PROJECT COMMENTS

PROJECT NUMBER:	SP2023-015
PROJECT NAME:	Site Plan for The Finch
SITE ADDRESS/LOCATIONS:	2610 SUNSET RIDGE DR

04/19/2023: SP2023-015; Site Plan for 2610 Sunset Ridge Drive

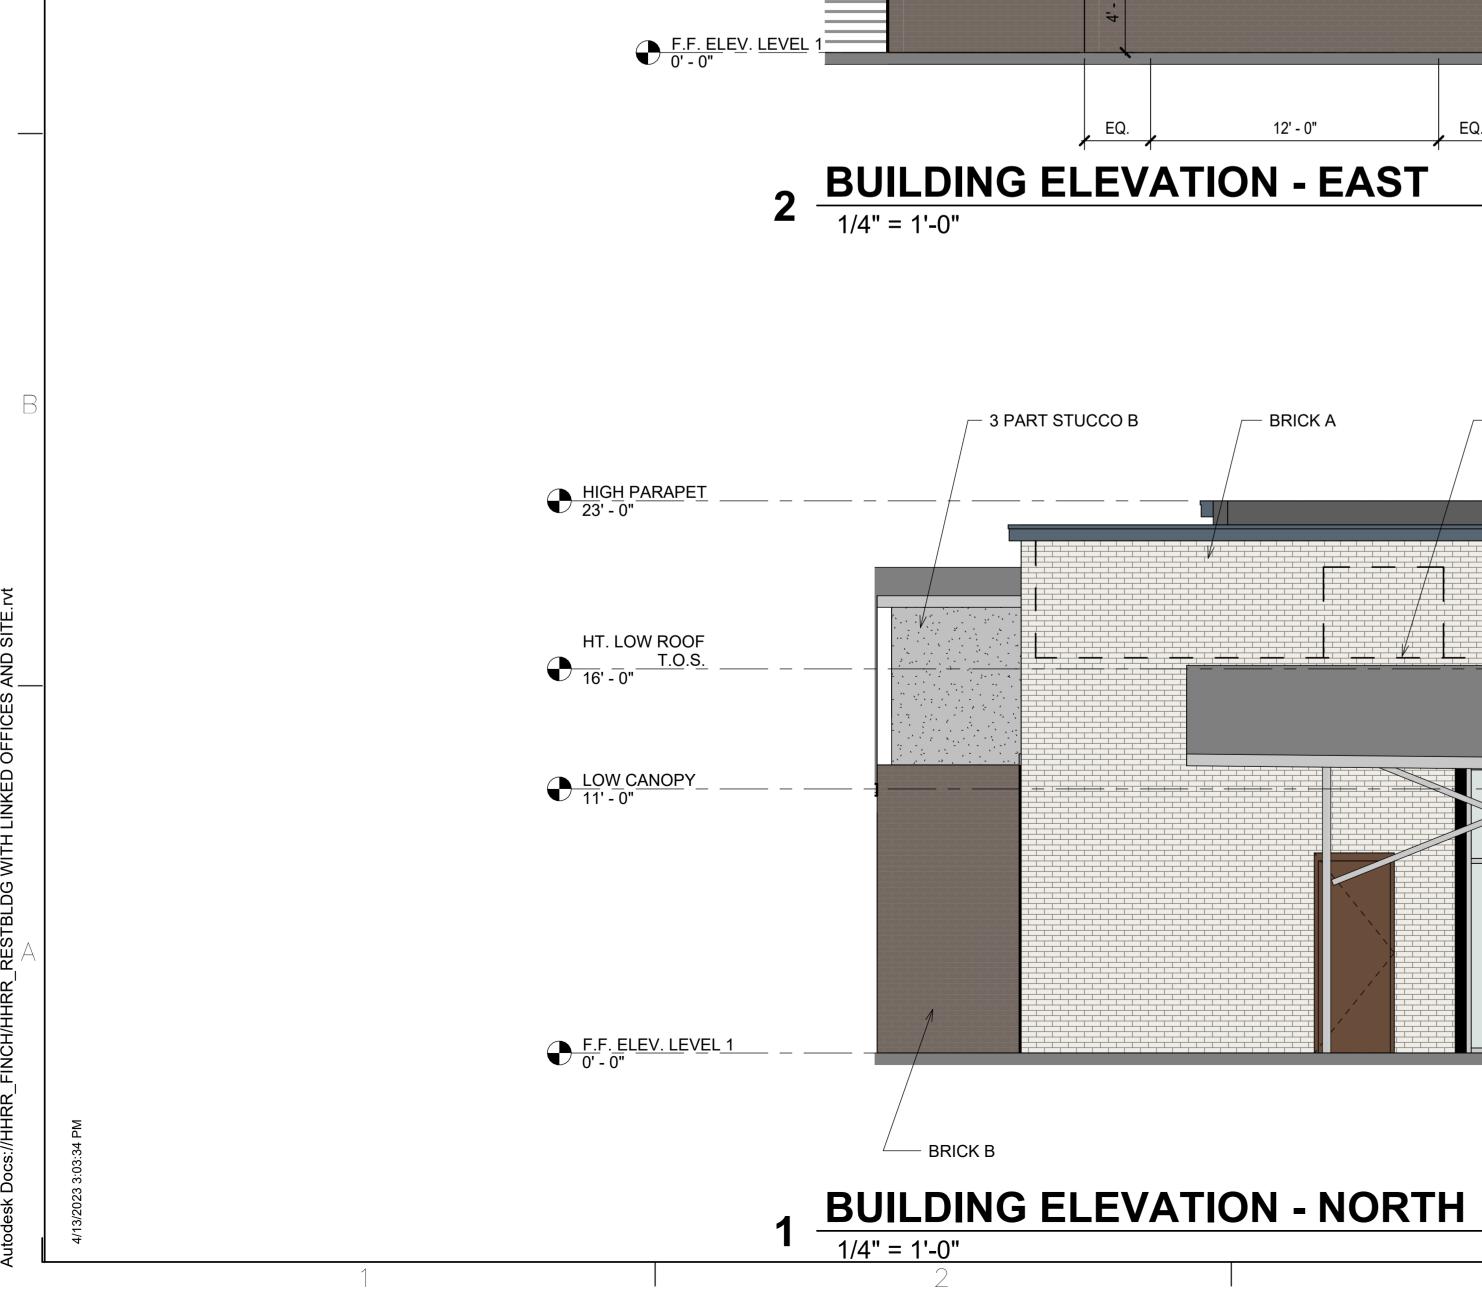
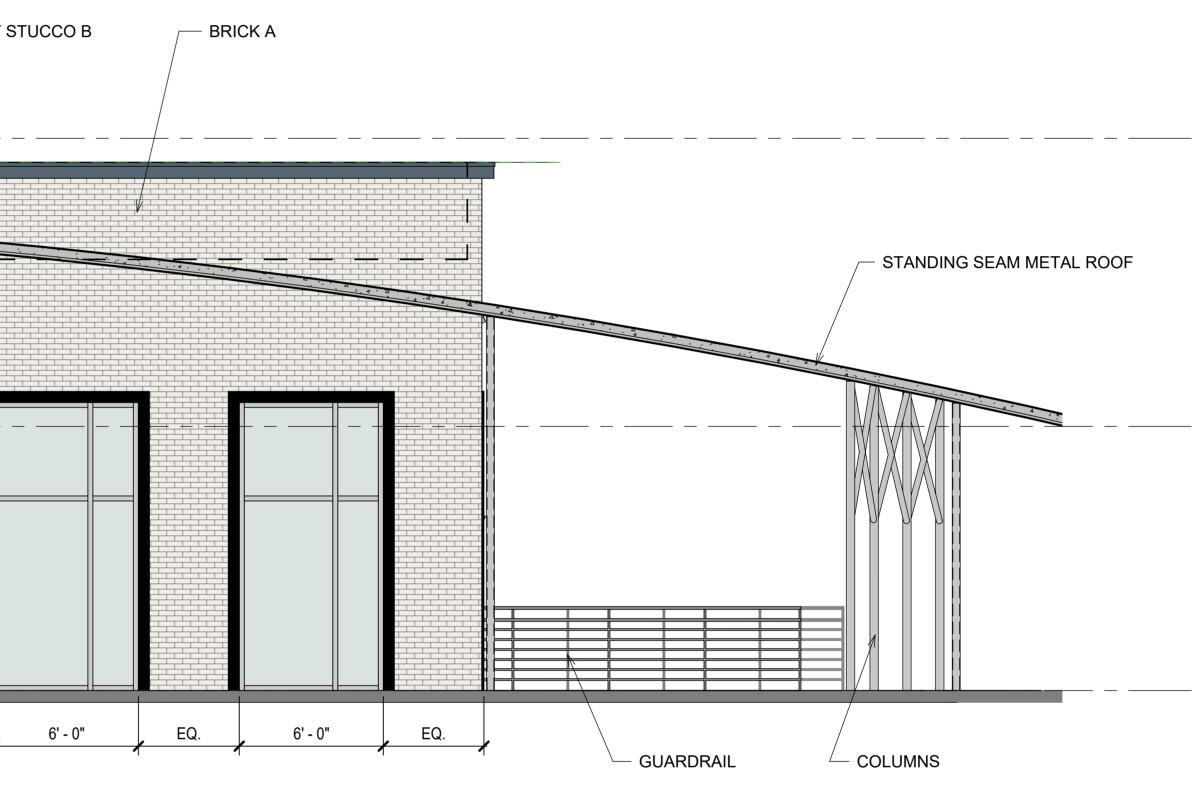
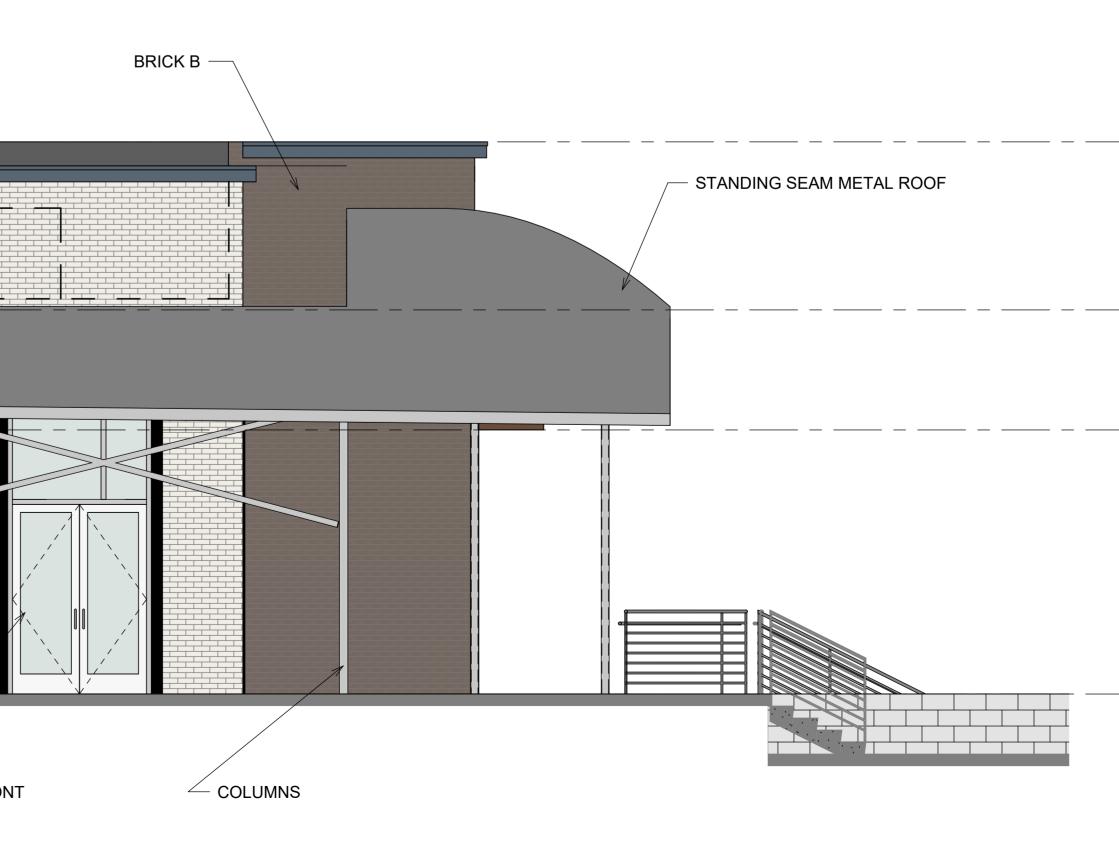
M.7 Building Elevations

(1) Indicate exterior elevations adjacent to public right-of-way.

(2) All buildings must be designed such that no roof mounted mechanical equipment, HVAC, or satellite dishes shall be visible from any direction. (Subsection 01.05.C, of Article 05, of the UDC)

(3) All parapets shall be extended back and finished on the interior side using the same materials as the exterior facing walls. (Subsection 04.01, of Article 05, of the UDC)

(4) A minimum of 20% natural or quarried stone is required on all building façades in an Overlay District. (Subsection 06.02.C.1(a)(1), of Article 05, of the UDC). This will require a variance from the Planning and Zoning Commission.

(5) The proposed buildings' facades do not meet the Commercial Building Articulation Standards for wall projections. (Subsection 04.01.C, of Article 05, of the UDC) This will require a variance from the Planning and Zoning Commission.

(6) All structures that have a building footprint of less than 6,000 SF shall be constructed with a pitched roof. (Subsection 06.02.C.2, of Article 05, of the UDC) This will require a variance from the Planning and Zoning Commission.

(7) All buildings shall be architecturally finished on all four (4) sides utilizing the same materials, detailing, articulation and features. (Subsection 06.02.5, of Article 05, of the UDC and Planned Development District 32 [Ordinance 19-25]). This will require a variance from the Planning and Zoning Commission. For compensatory, dress up the South elevation with a couple architectural elements (i.e. an arcade) and varying materials as this elevation will be visible from Sunset Ridge.

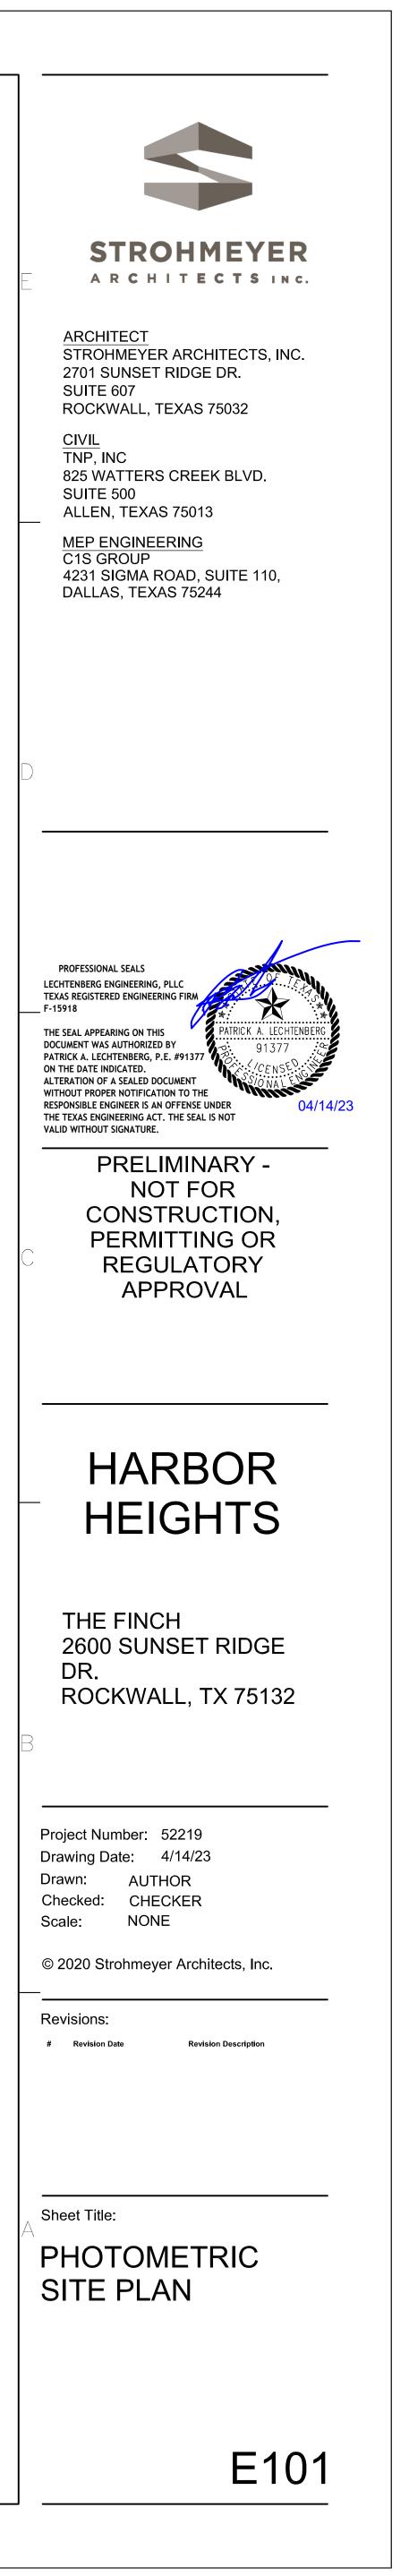
(2) Pad mounted utility equipment, and air conditioning units, shall be screened from horizontal view from any adjacent public street and from any adjacent property. Utility equipment and air conditioning units shall be screened utilizing plantings berms, or walls matching the main structure. (Subsection 01.05.C, Article 05, of the UDC) Please indicate on your site plan if there are any pad mounted utility equipment. Utility equipment will be subject to screening if found later at engineering or building permit.
M.6 Photometric Plan

(1) The allowable maximum light intensity measured at the property line of a non-residential property shall be 0.2 of one foot candle. (Subsection 3.03.C, of Article 07, of the UDC)

(2) Please provide lighting cut sheets that indicate the wattage for each exterior lighting fixture. Light sources (e.g. light bulbs) shall be oriented down and toward the center of the site or shielded so as to not be visible from the property line. (Subsection 03.03.A, of Article 07, of the UDC)
